ATLANTIC PILOTAGE AUTHORITY

HERRING COVE BREAKWATER REPLACEMENT

CONTRACT NO. 190248.00

ADDENDUM NO. 1

DRAWING S01 EXISTING CONDITIONS AND REMOVALS

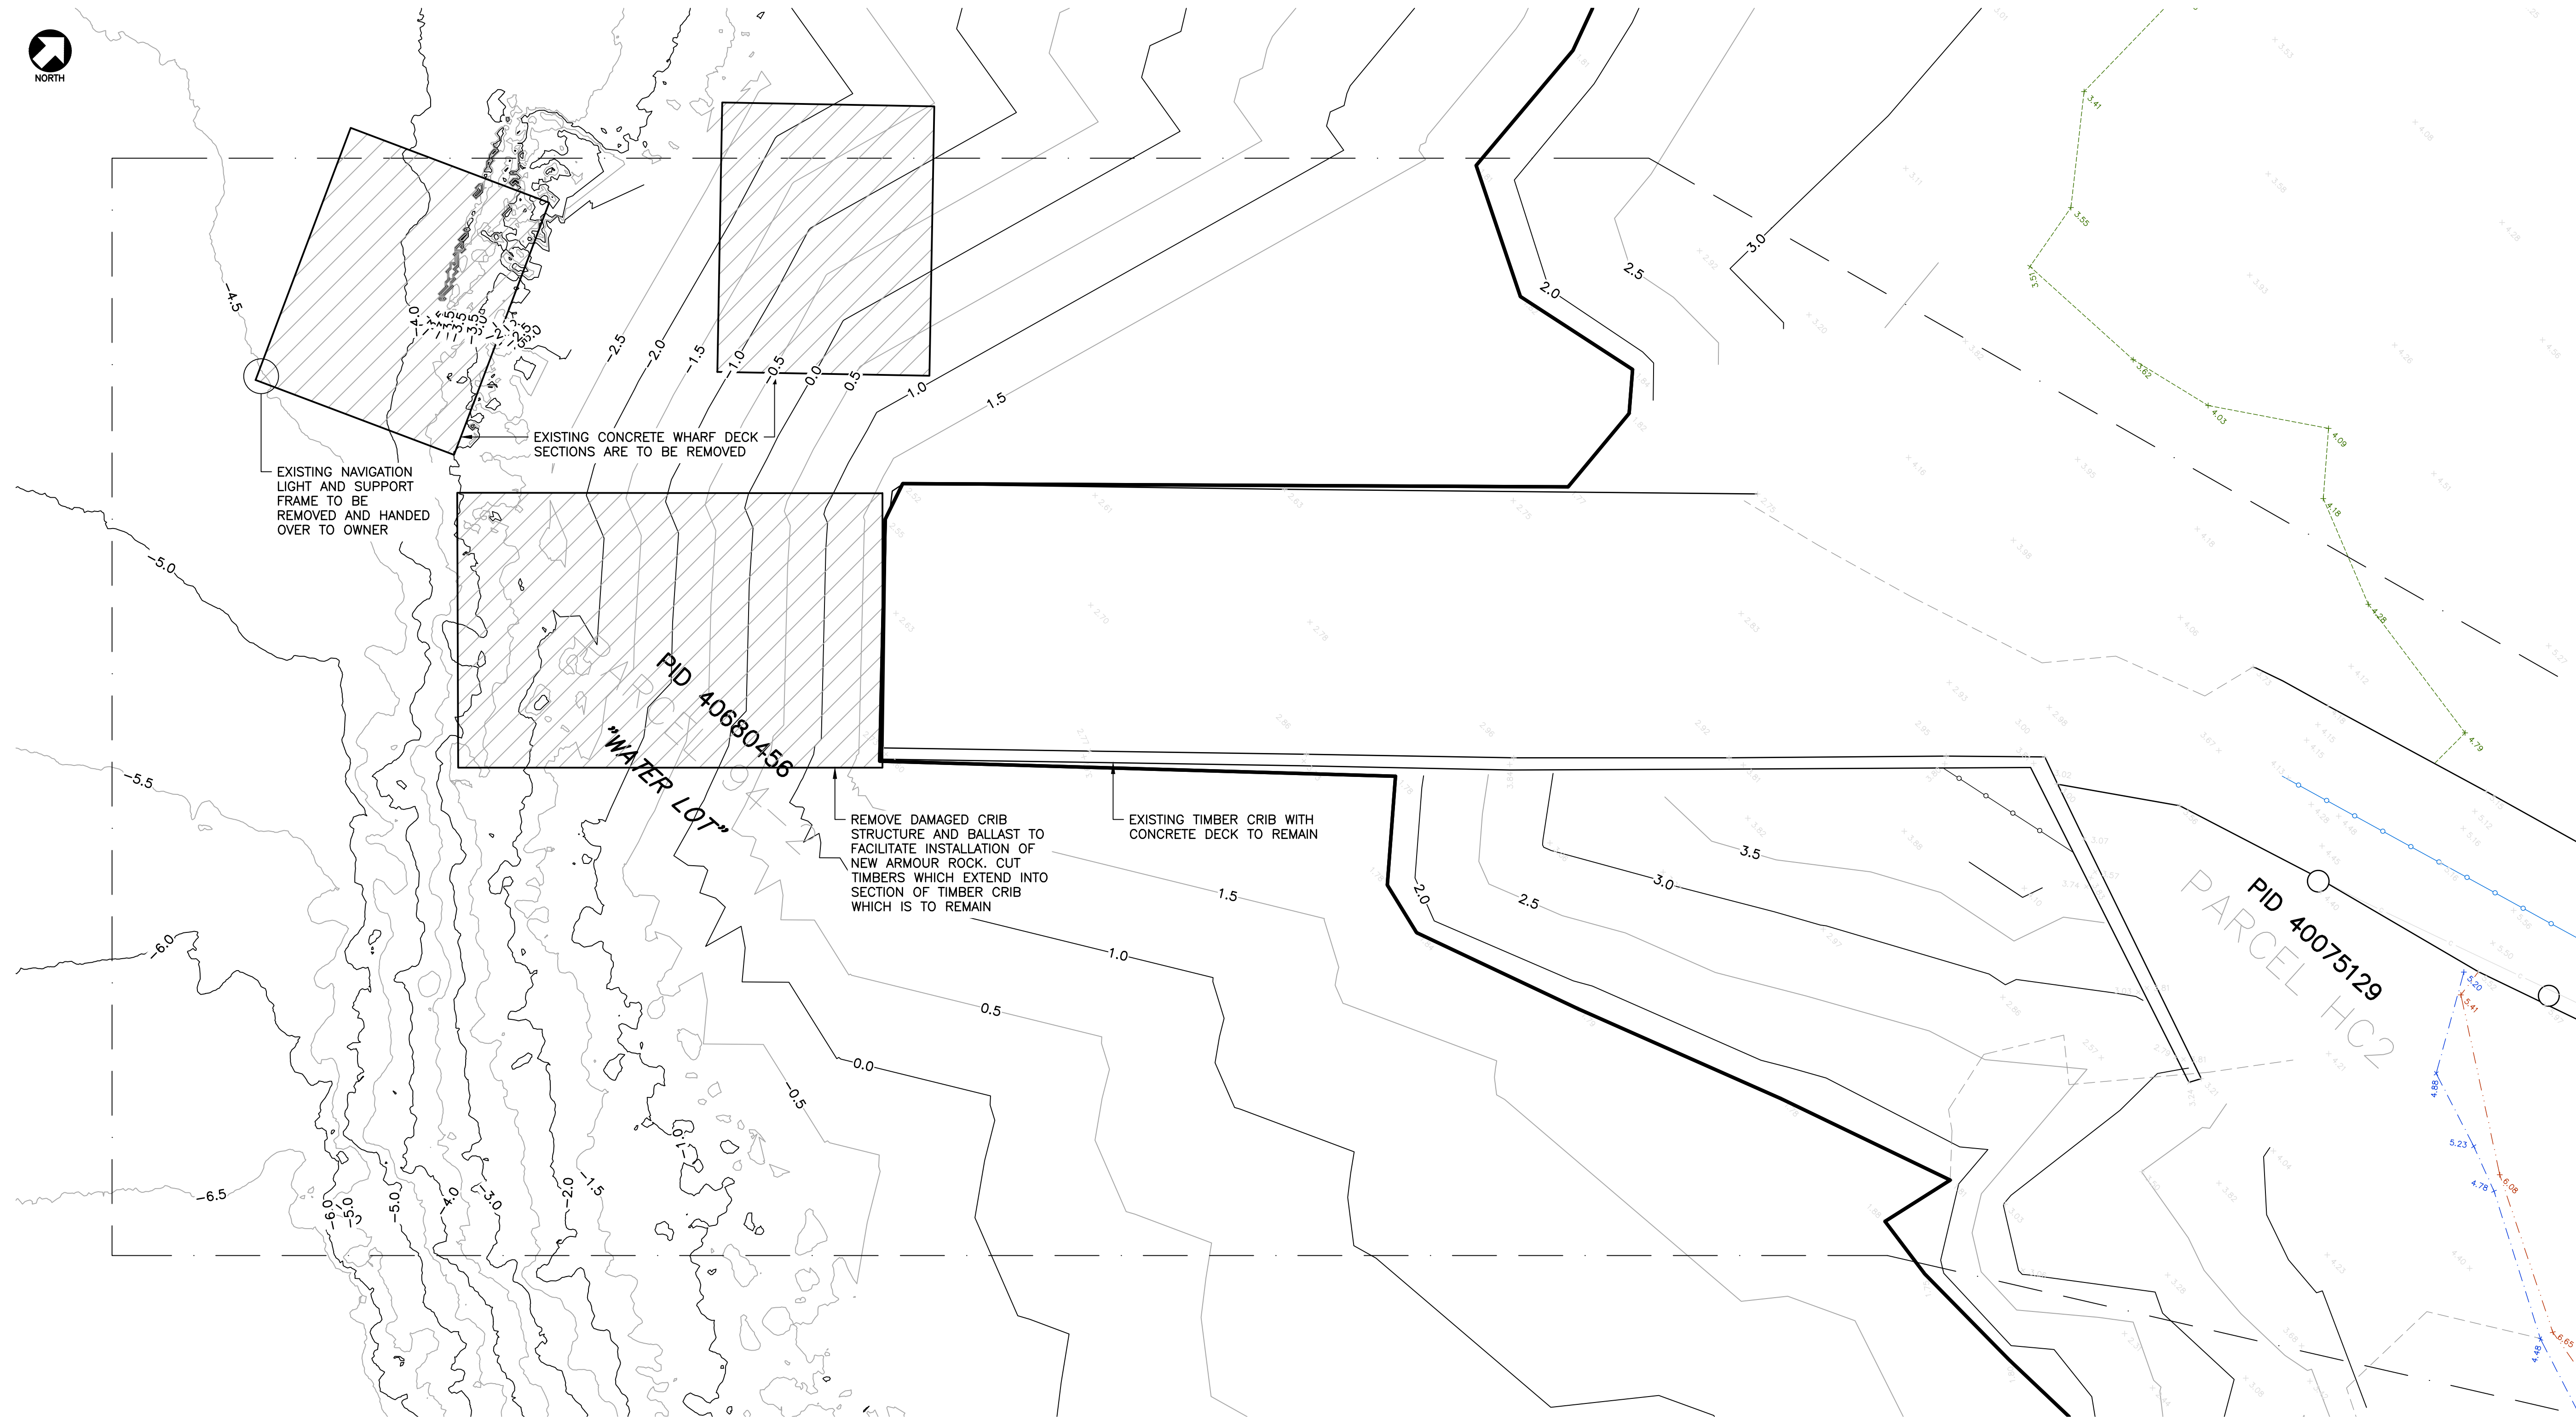
Replace with attached Drawing S01 – EXISTING CONDITIONS AND REMOVALS, elevation marks added to plan contours, Re-Issued for Tender, dated Feb. 28/20.
